Preliminary Consultation MONTGOMERY COUNTY HISTORIC PRESERVATION COMMISSION STAFF REPORT

Address: Smith Drive., Silver Spring Meeting Date: 11/12/2025

National Park Seminary Historic District

Proposal: Building Rehabilitation of the Castle and Villa Buildings and Construction of a New

4 OF 4. PROPOSED TOWNHOME NORTHTH ROW ELEVATIONS

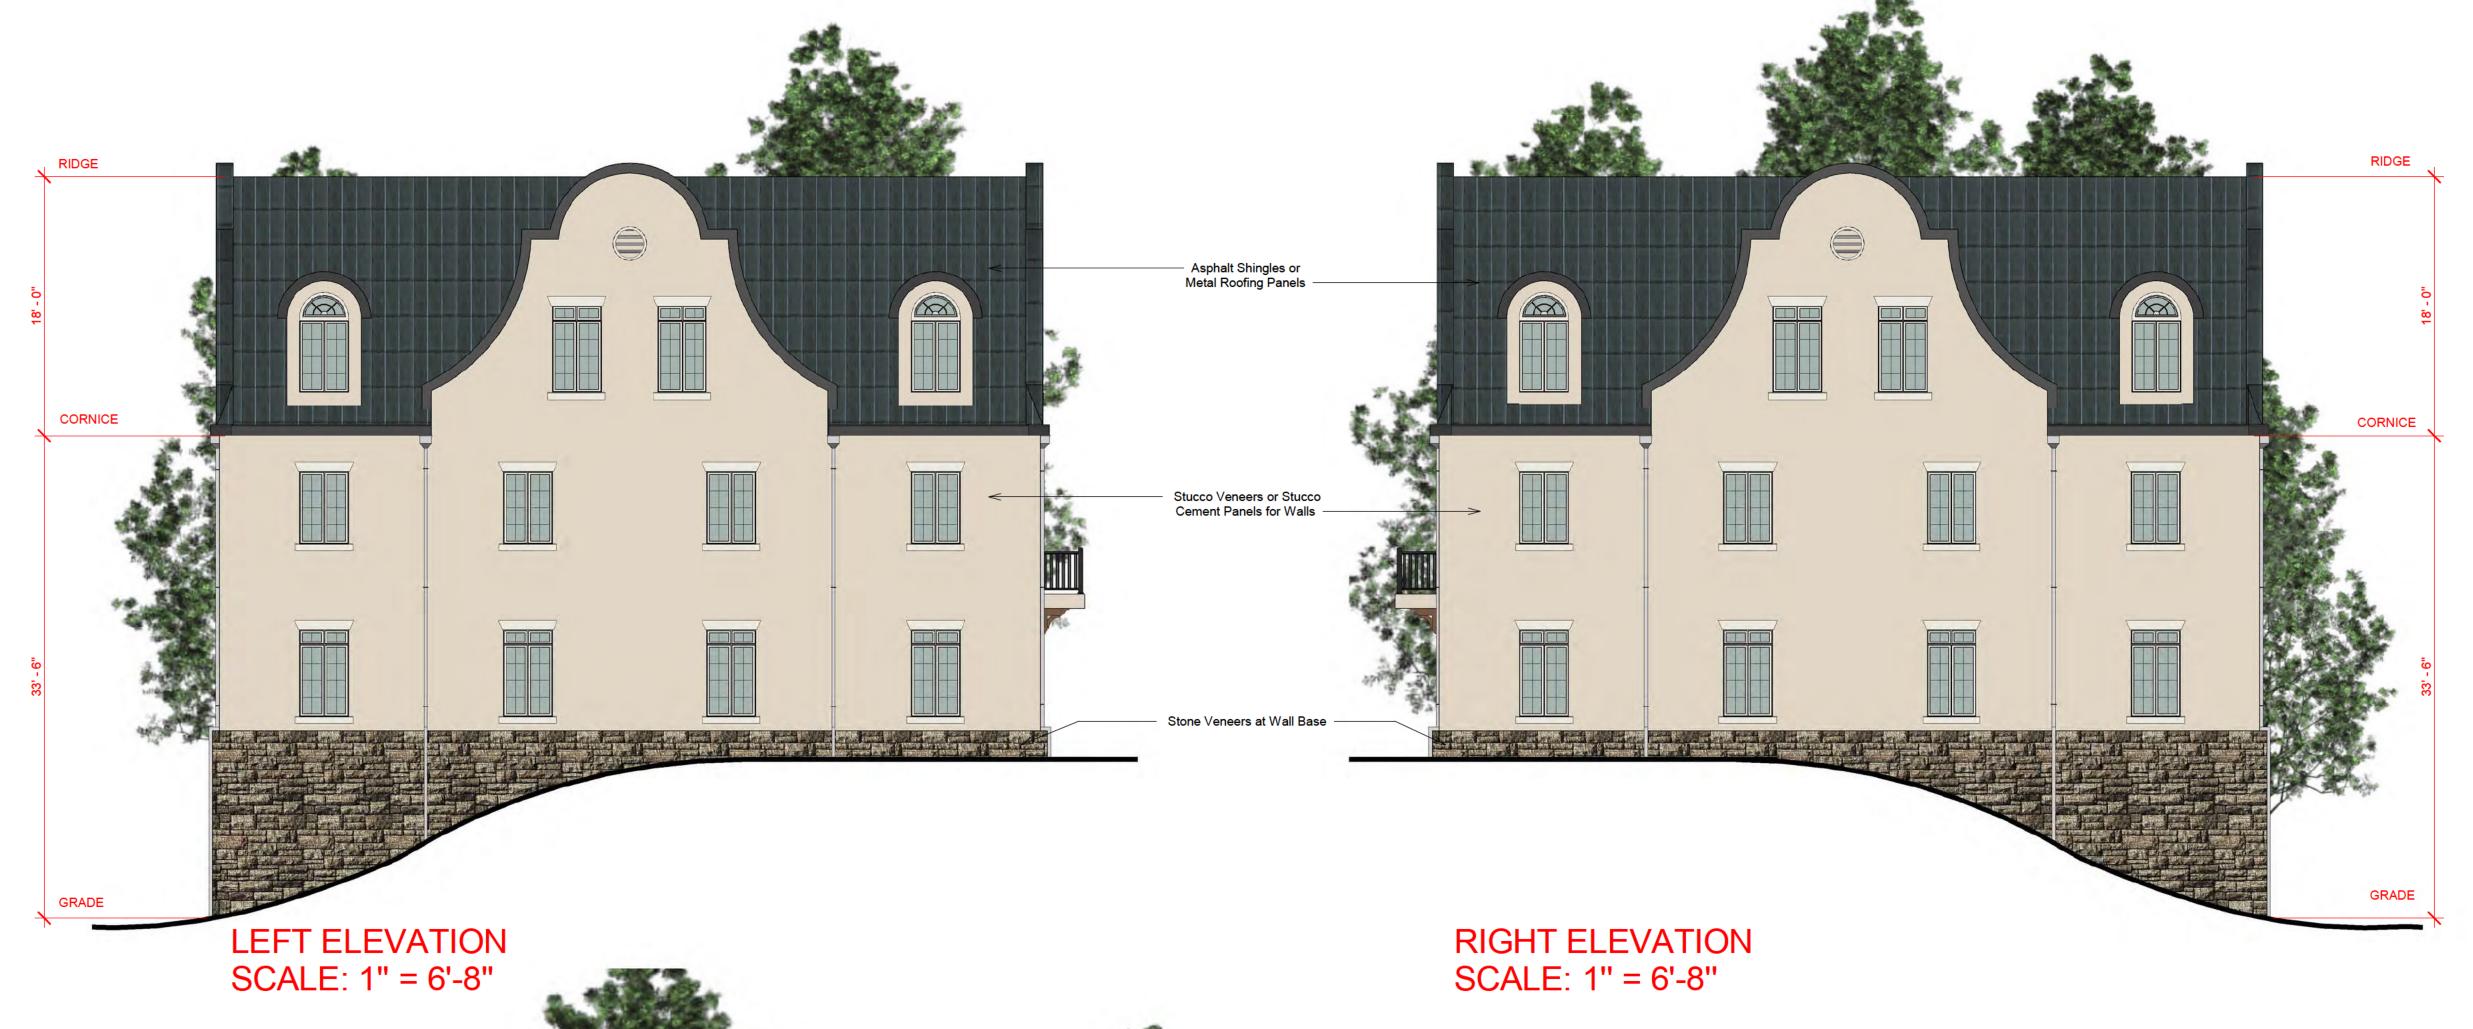
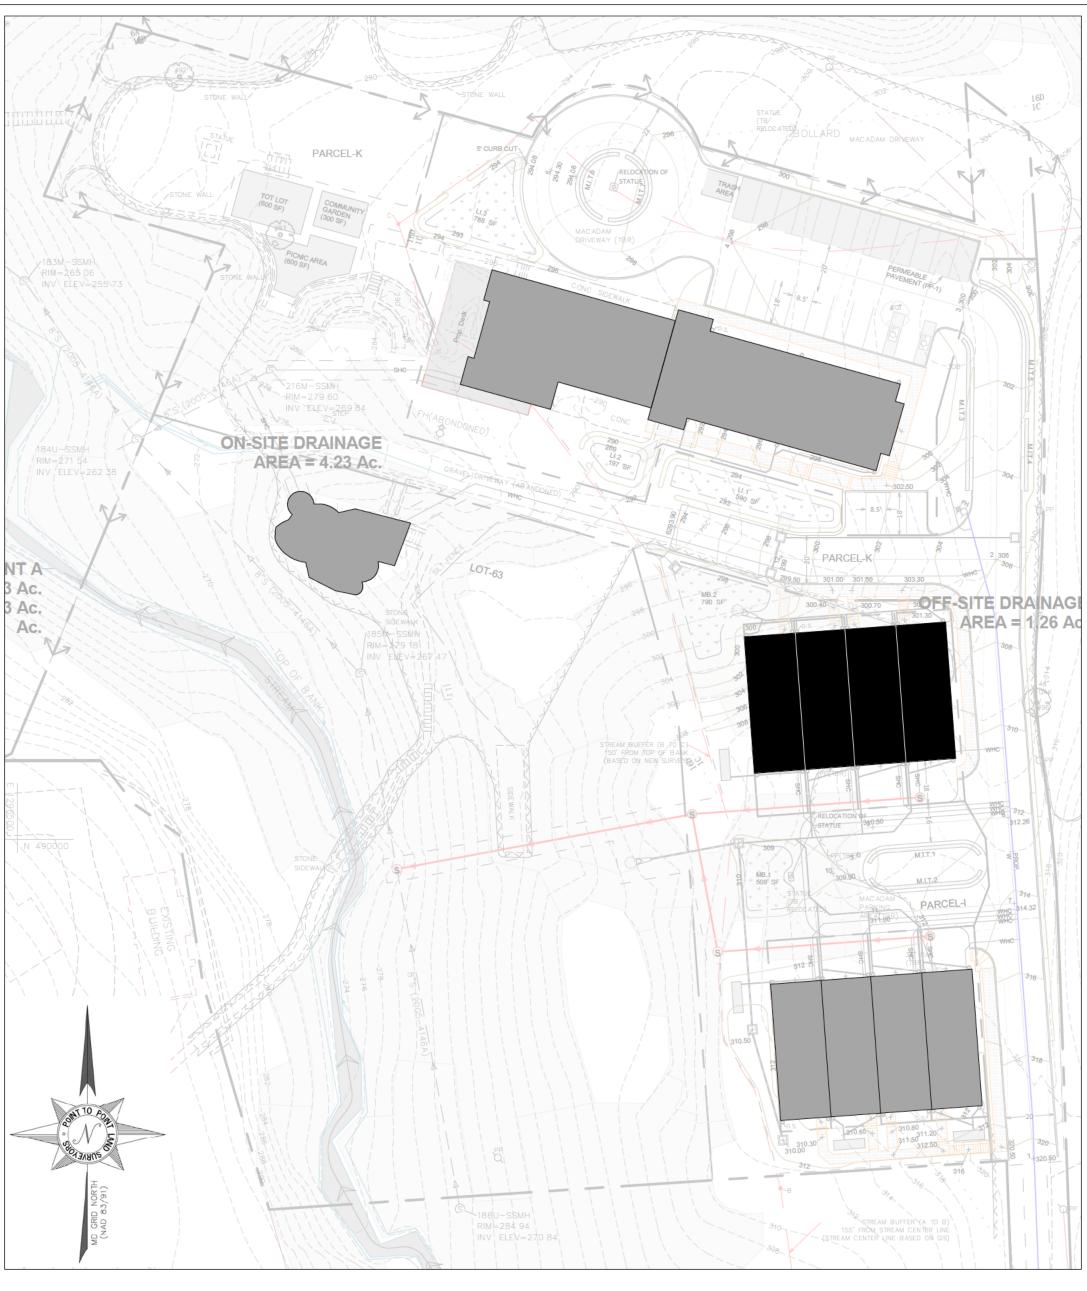
Based on the notes on the drawings, both buildings will be 49' (forty-nine feet) tall from grade and approximately 84' (eighty-four feet) wide. The townhouse buildings will be oriented so the 'rear' garages are accessible from a central driveway. Both buildings will have a stone veneer ground floor with stucco above. No other material specifications were included in the submitted materials.

Staff finds the proposed location to be appropriate. The townhouses are set apart from the historic buildings and will not impact the relationship between the Villa and the Castle. Staff finds the form of the two four-unit buildings is sufficiently contemporary and that they will not be misidentified as historic construction (per *Standard #9*).

Staff finds the footprint of the proposed townhouse buildingss are generally consistent with what was construced in the western portion of the site. The height of the proposed townhouses appear to be slighly taller than the previously constructed townhouses; perhaps by as much as 5' (five feet) however, Staff does not find these two buildings will overwhelm either the Castle or the Villa, as the new buildings will be separated from the historic both in distance and grade so they stand apart.

Staff finds that stucco siding is generally appropriate for new construction in this area of the historic

district, as it is used on both the Villa and portions of the Castle. Recent experience with stucco cement panels leads Staff to recommends against them as the expansion joints create an appearance that is not consistent with traditional architecture. Information on the other materials, except for the asphalt shingles, was not provided and should be included with the next submission. Staff finds that in the National Park Seminary most of the materials should be those employed in traditional architecture (i.e., wood doors, wood or metal clad windows, cement stucco siding, etc.).

Staff requests the following information at the next Preliminary Consultation:

- Annotated elevation drawings and
- Detailed material specifications.
